Project	IEEE 802.16 Broadband Wireless Access Working Group < http://ieee802.org/16 >		
Title	Clarifications for AAS Zone		
Date Submitted	2005-3-15		
Source(s)	Dave Pechner, Doug Dahlby, Todd Chauvin	ArrayComm Inc.	dpechner@arraycomm.com , dahlby@arraycomm.com , chauvin@arraycomm.com ,
Re:	IEEE P802_Cor1_D1		
Abstract	This contribution introduces clarifications for an AAS zone in the OFDMA PHY		
Purpose	Adopt into P802.16d/D5 corrigenda		
Notice	This document has been prepared to assist IEEE 802.16. It is offered as a basis for discussion and is not binding on the contributing individual(s) or organization(s). The material in this document is subject to change in form and content after further study. The contributor(s) reserve(s) the right to add, amend or withdraw material contained herein.		
Release	The contributor grants a free, irrevocable license to the IEEE to incorporate material contained in this contribution, and any modifications thereof, in the creation of an IEEE Standards publication; to copyright in the IEEE's name any IEEE Standards publication even though it may include portions of this contribution; and at the IEEE's sole discretion to permit others to reproduce i

Figure 224a shows a legal UL AAS zone with an UIUC 12,13 allocation that is an integer number of slots in duration.

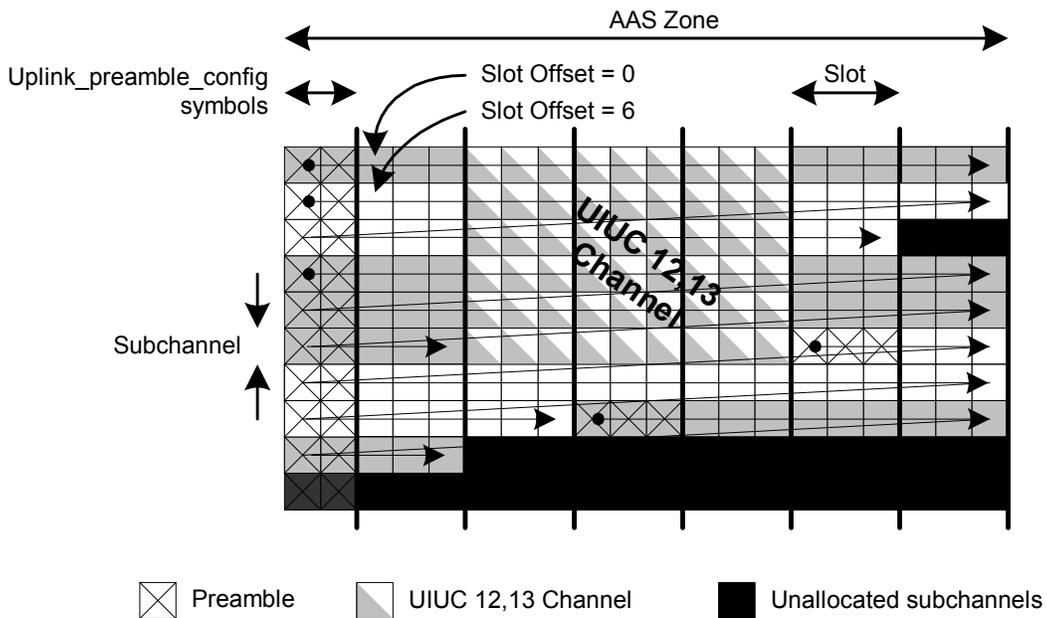
- When used in an AAS zone, a UIUC 12,13 region shall ~~either span all subchannels and consist of an arbitrary number of symbols, or be constrained to~~ be a multiple of 3 symbols in duration.

- ~~In the absence of a UIUC 12,13 region that spans all subchannels,~~ an UL AAS Zone shall consist of an integer number of slots plus the number of UL AAS preamble symbols as defined in by the “Uplink_preamble_config” field of the UL_AAS_IE and AAS_DLFP.

[replace Figure 224a with the following:]
